4 January 2024

Our Ref: 2024/003951
File No: R/2023/22
R/2014/7/C

**USYD and RPA Sydney Biomedical Accelerator Project
Advice on SSD-55388456 – Environmental Impact Statement**

Figure 1: Extract from eastern elevation (D0353 A05_1102, DCM)

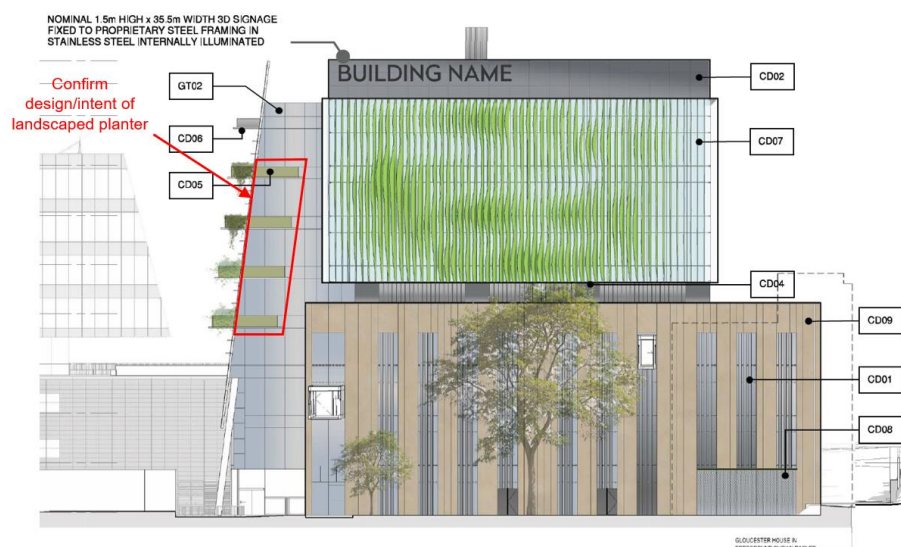
Landscaped planters along the eastern and western elevations adjacent to the raked northern facade are shown in the submitted montages, however, have not been detailed in the submitted architectural plans (refer to figure 1 & 2 below). Should the intent be to wrap around the landscaped planters than the architectural plans should be amended to detail this element and ensure the feasibility of the proposed landscaping as addressed additionally above.
